ADDENDUM 2

DATE: May 26, 2020

Contract 19-C-00053 David L Tippin Facility Solids Processing System Improvements

WORK ORDER NO. WTR-18-0009
RECORD DRAWING NO.
ATLAS PAGE D-14 SHEET 23 OF 23

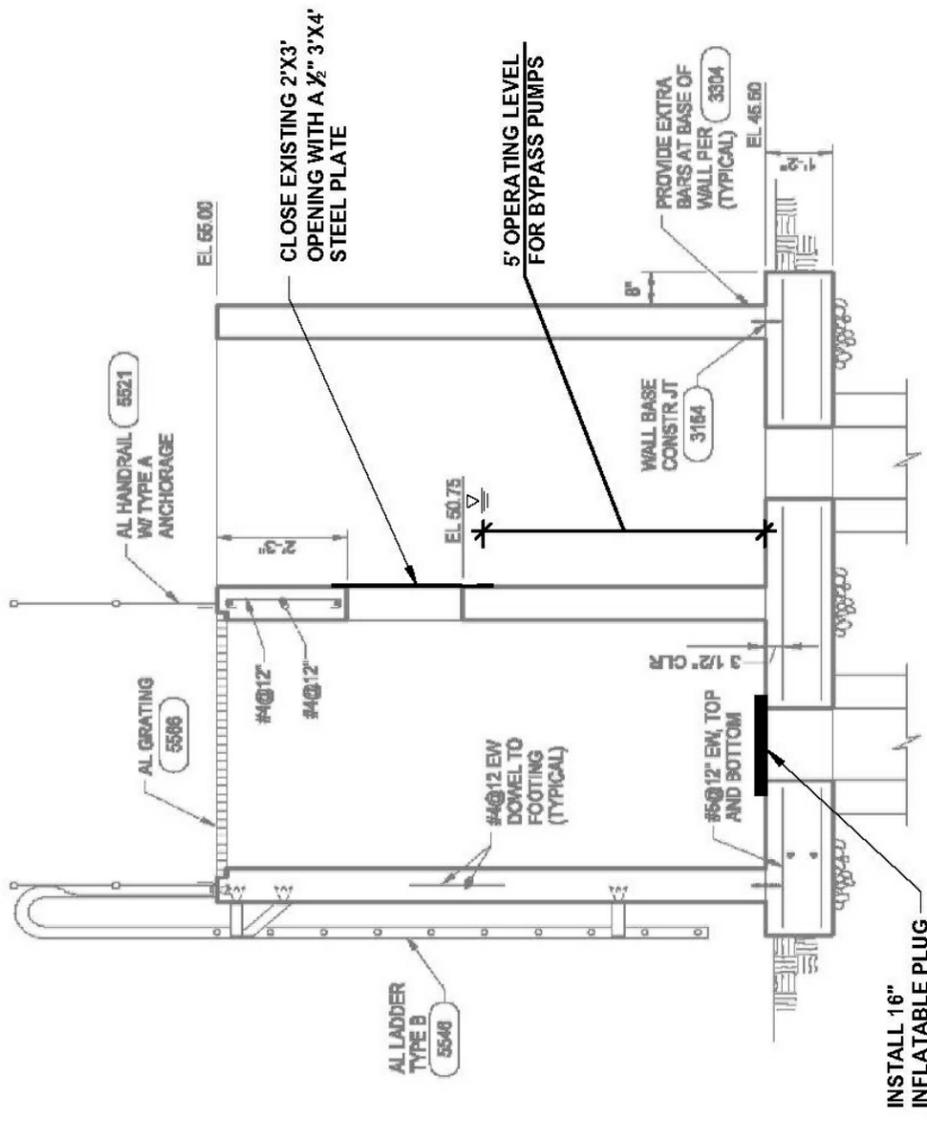
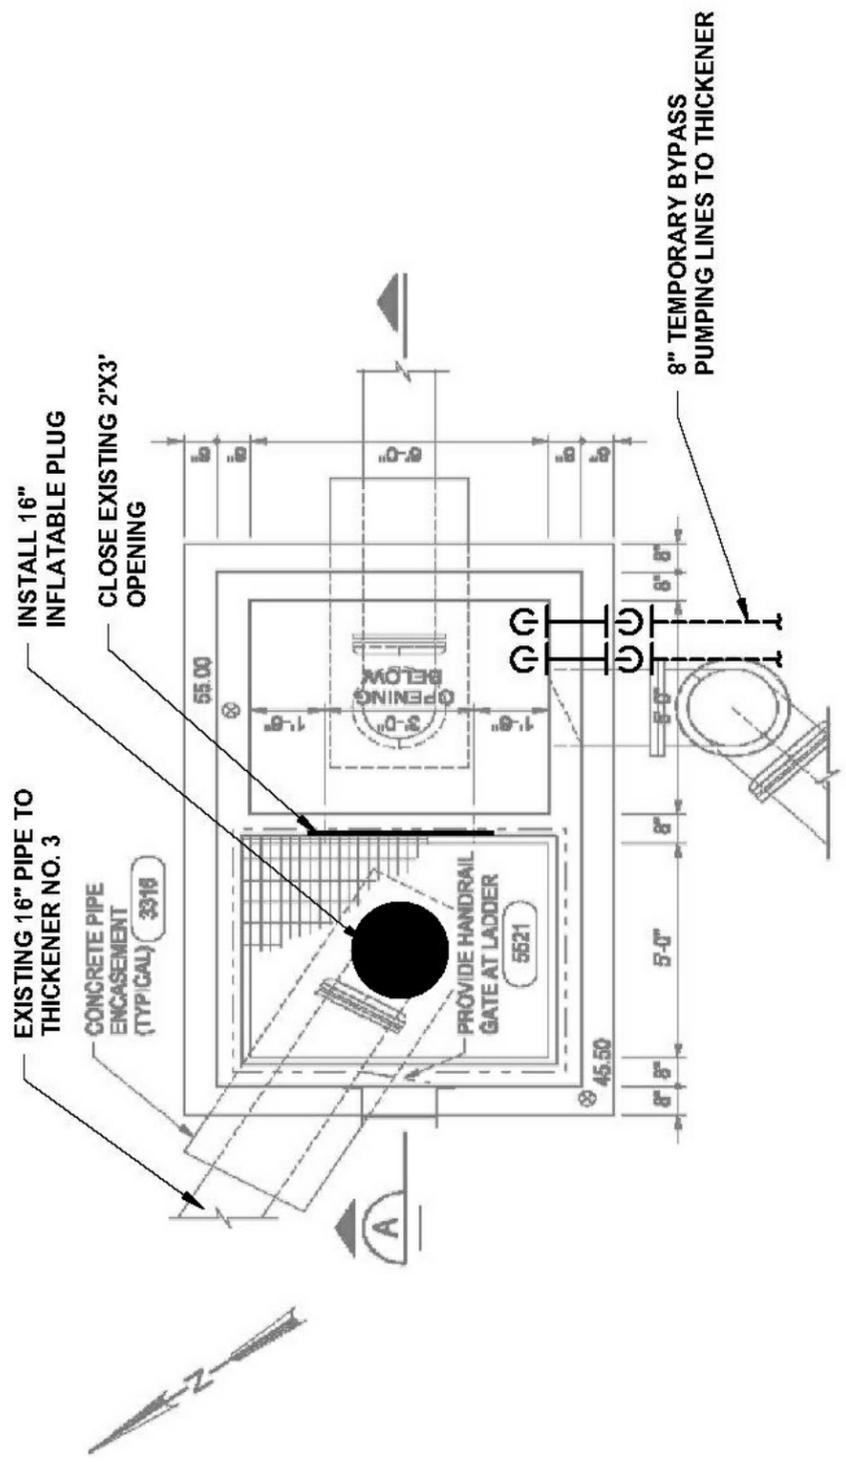
Item 1: Replace plan sheet 23 with the attached plan sheet 23.
